Project	IEEE 802.16 Broadband Wireless Access Working Group < http://ieee802.org/16 >	
Title	RS network entry procedure	
Date Submitted	2007-03-105	
Source(s)	<p>Mike Hart, Yuefeng Zhou, Sunil Vadgama Fujitsu Laboratories of Europe Ltd. Hayes Park Central Hayes, Middx, UB4 8FE, UK</p> <p>Sungjin Lee, Hyunjeong Kang, Hyoungkyu Lim Samsung Electronics</p>	<p>Voice: +44 20 8606 4523 Fax: +44 20 8606 4539 mike.hart@uk.fujitsu.com</p> <p>Voice: +82 31 279 5248 Fax: +82 31 279 5130 E-mail : steve.lee@samsung.com</p>
Re:	Call for technical proposals 802.16j-076/007r234	
Abstract	<p>This contribution provides a technical proposal for the RS network entry procedure for the case of a non-transparent RS. It is based on reusing many of the stages executed in the SS network entry procedure with the only major change being the introduction of new SBC and REG TLV values to enable exchange of information about PHY & MAC features supported by the RS. It also defines how the RS switches from using the access link to using the relay link following successful registration with the MR-BS.</p>

RS network entry procedure

Fig. xxx RS initialization overview

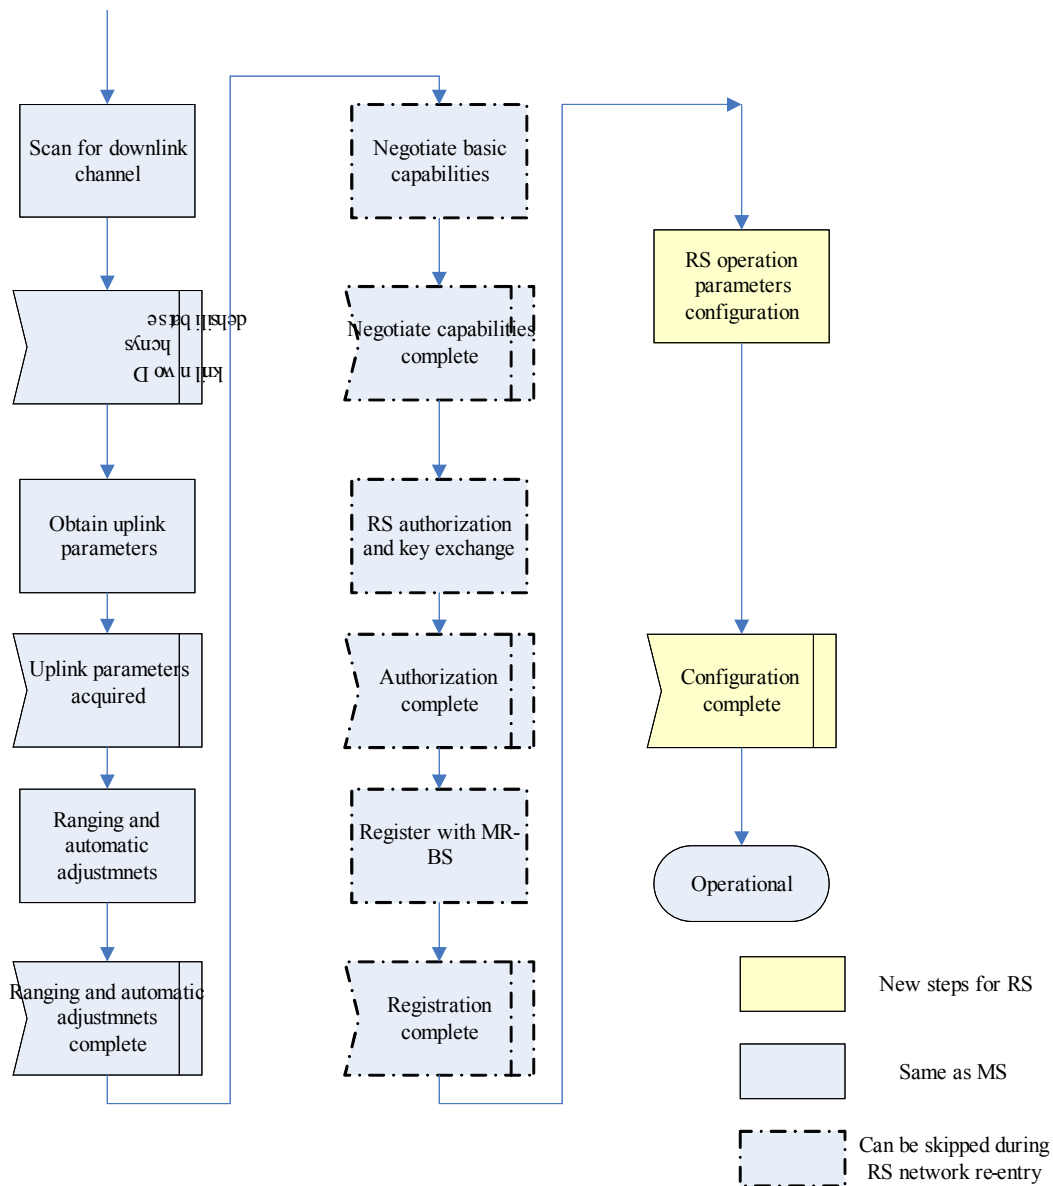
The procedure for initialization of an RS shall be as shown in Figure xxx55. For the RS the stages ~~e)~~, g), h), i) and j) are not required, for all other stages the RS shall behave in the same manner as an SS during network entry unless otherwise specified in the subclauses of 6.3.9. The more detailed finite state machine representations of the individual sections (including error paths) and the timeout values shall be the same as those provided for the SS, unless otherwise specified.

[Insert the following figure]
